# **Hazelbrook Station Upgrade**

# **Hazelbrook Station Upgrade Determination Report**

**Transport Access Program  
Ref - 6200904**

Figure 2 Modified station building internal layout

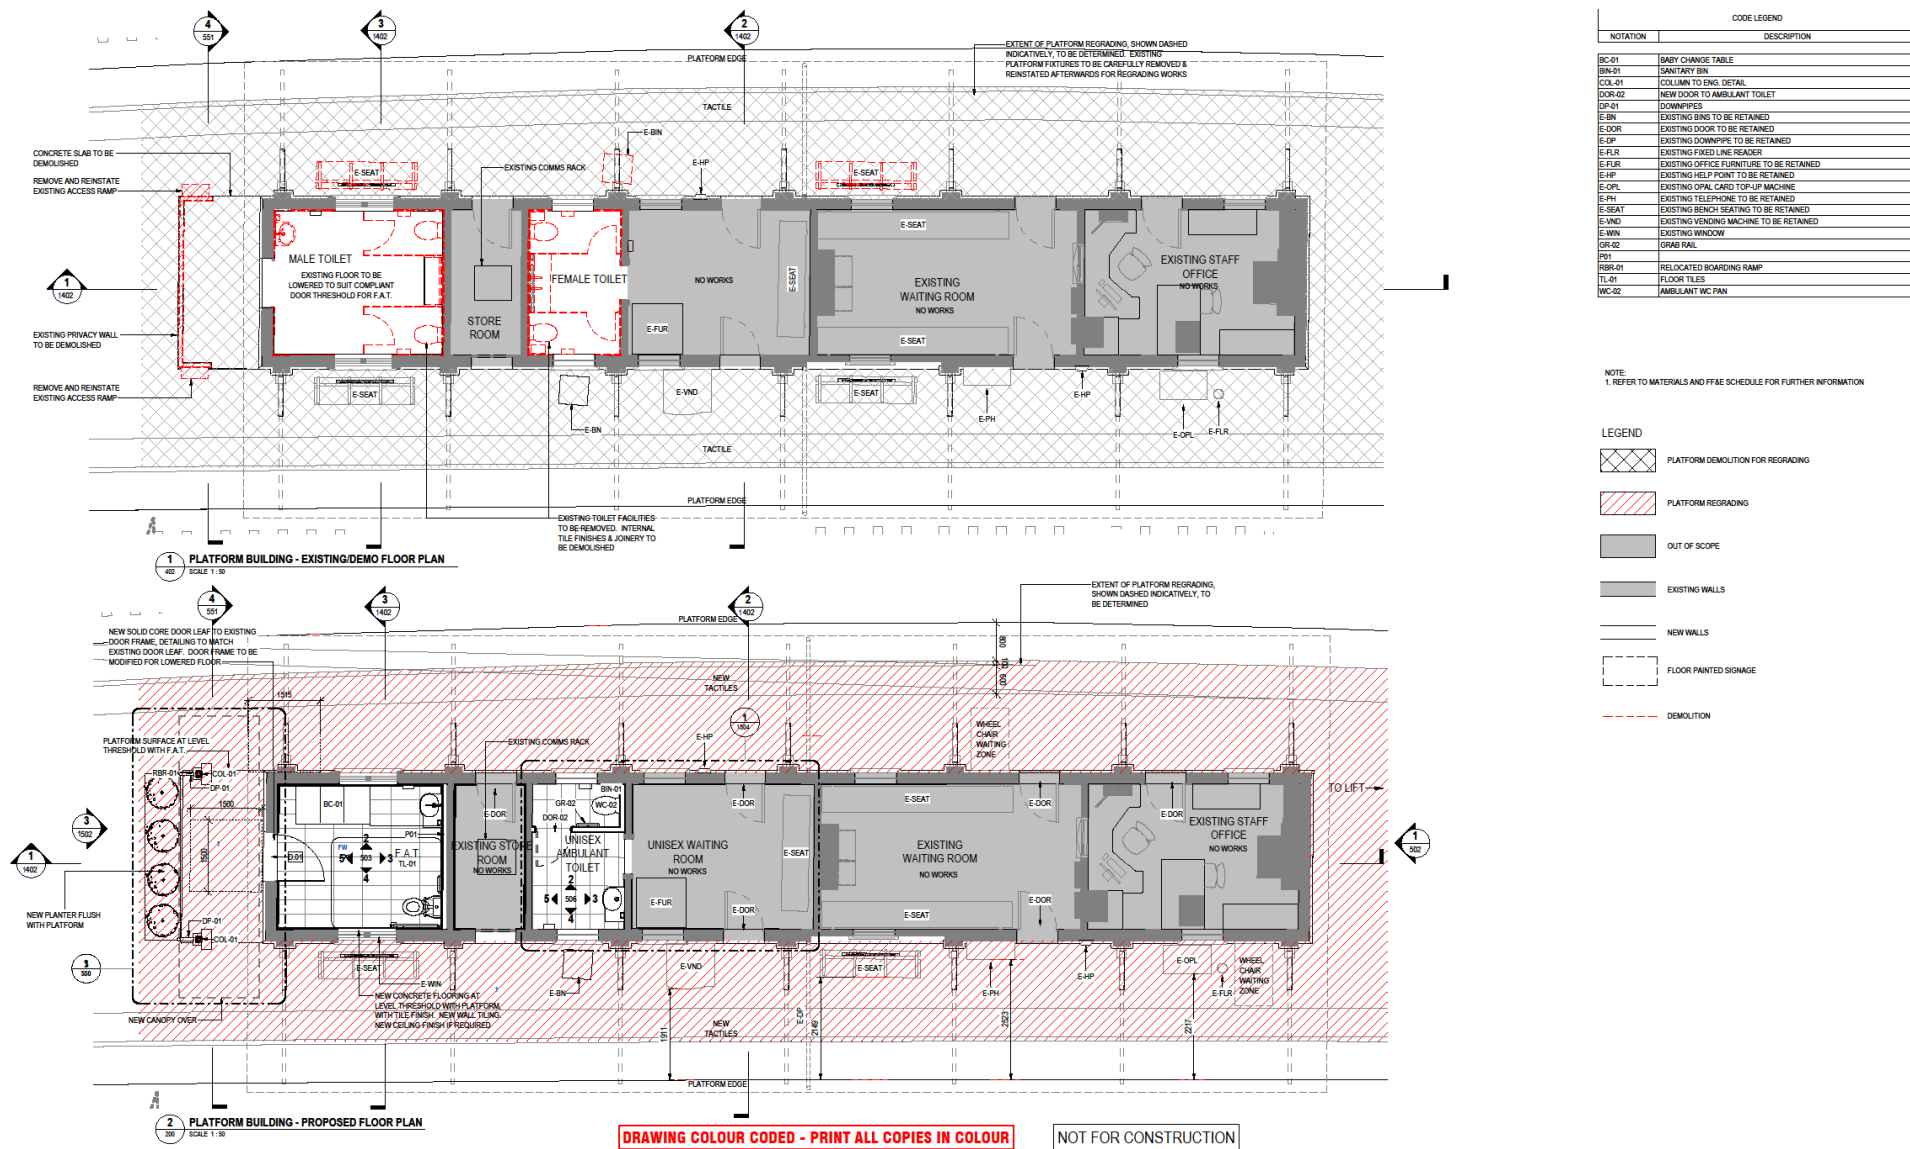
Aspect of the Proposal	Design change	Discussion of impact
Station building	<p>There would be a reduction in the works to the internal reconfiguration of the station building as follows (refer to Figure 2):</p> <ul style="list-style-type: none"><li>• The existing female toilet would be converted to a unisex ambulant toilet</li><li>• The station services equipment room (SSER) is no longer required</li><li>• There would be no modification to the existing store room and waiting room area adjacent to the existing female toilets</li><li>• The existing equipment rack would be used to house communications equipment in the store room (i.e. no change).</li></ul>	<p>The changes related to potential heritage impacts and a heritage assessment has been completed by Extent Heritage (refer to Appendix C). The assessment found that overall, the changes represent a reduction in impacts to heritage values (through avoiding direct impacts to heritage fabric) and amendments and mitigation measures recommended in the <i>Hazelbrook Statement of Heritage Impact</i> (Extent, 2018). Consideration for the revised mitigation measures has been included in the Conditions of Approval 29, 30 and 31.</p>
